Access Compliance Report

Public Rights-of-Way

(Curb Ramps)

Intersection ID: 53180	Main Street: ELLINGTON_PARK_DR	Cross Street: BASIE_PARK_CT	Location: NE
ADA ID: 43E8721BB0D5	Ramp Type: Perp	Initial Pass/Fail: Pass	Overall Compliance: No
Severity Score: 0			
Codes/Mitigation Info/Possible Solution		Field Measurements/Component Compliance

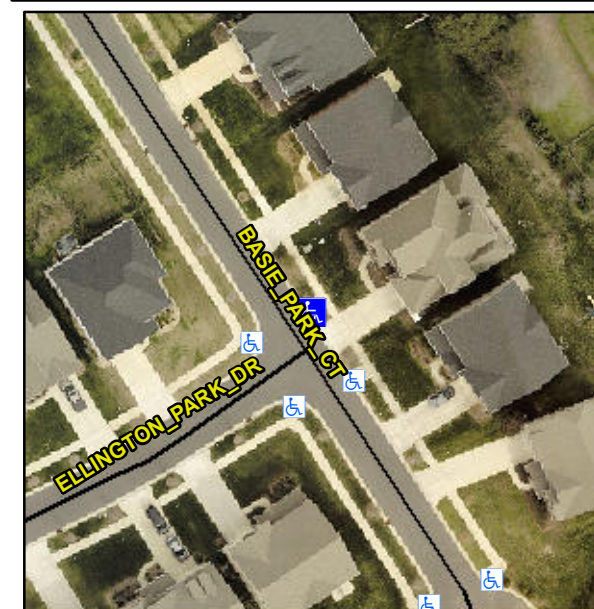
Not Found, R304.2.2-Perp, R304.3.2-Para, R305.2

Remove & Replace Entire Ramp.
